Notice of Allowability	Application No.	Applicant(s)	
	10/648,738	HAJIANPOUR, ZOYA ED	
	Examiner	Art Unit	
	LIEN TM NGO	3727

EXAMINER'S AMENDMENT

FIG. 1

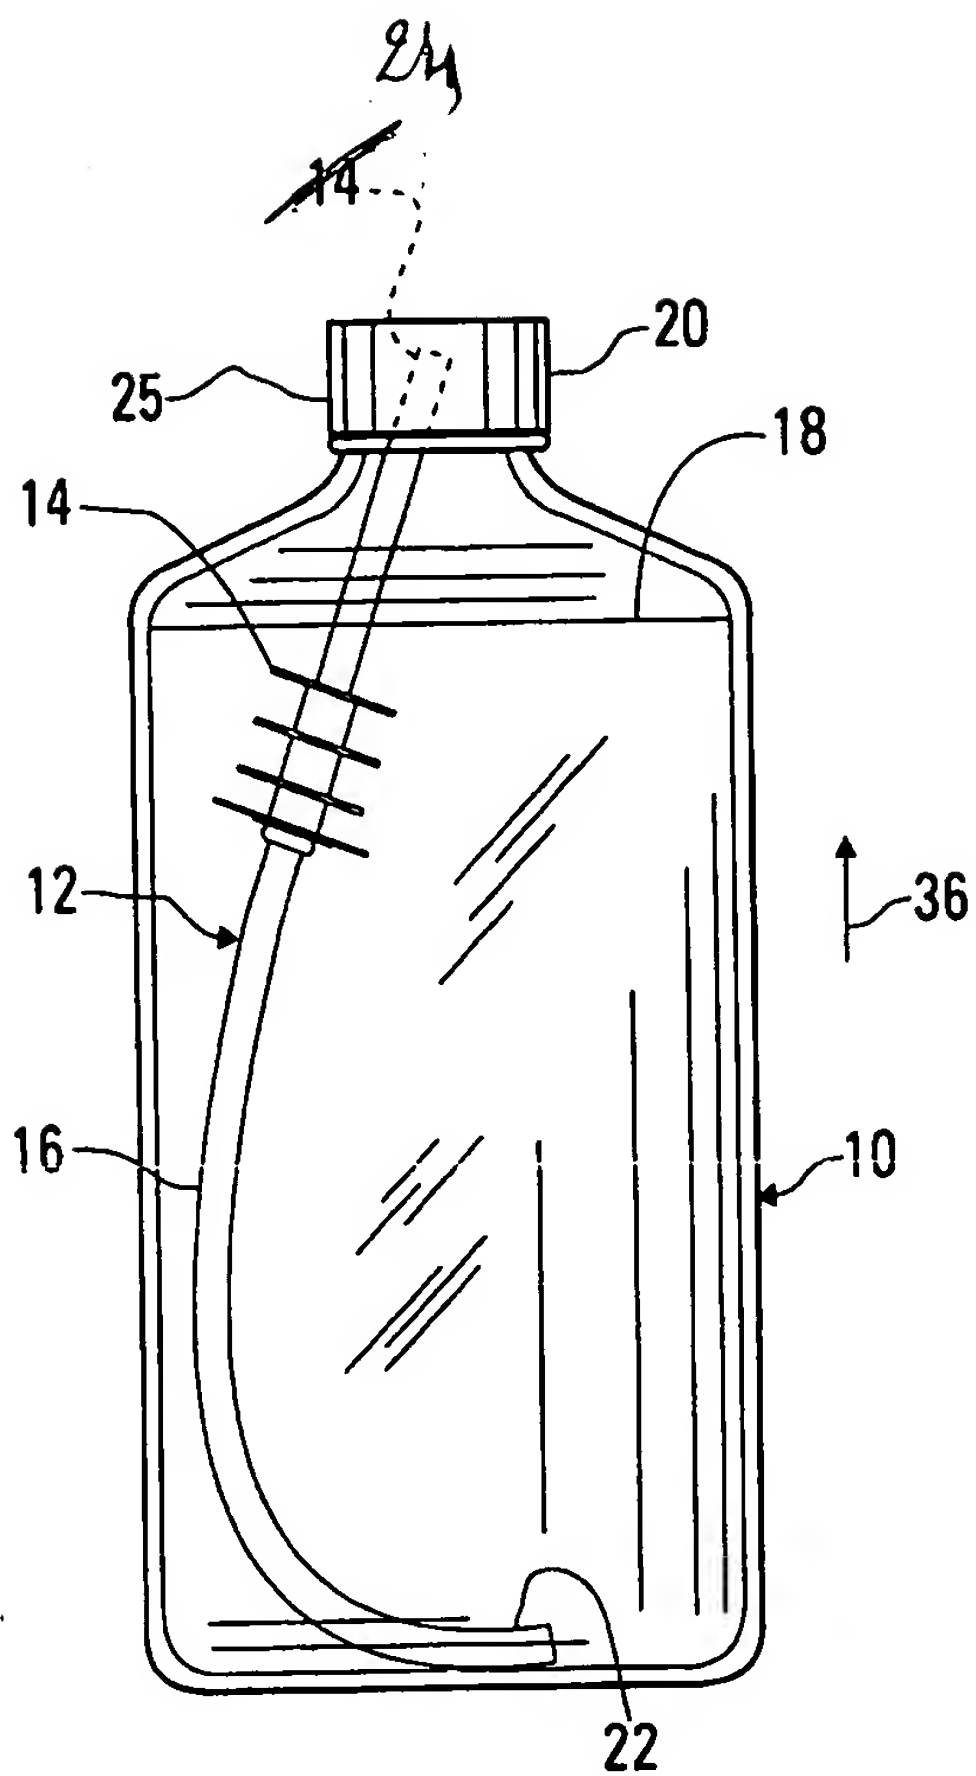
4. The following changes to the drawings have been made by the examiner: In fig 1, number "14", showing the upper end of the straw, has been changed to "24". In order to avoid abandonment of the application, applicant must make these above agreed upon drawing changes.
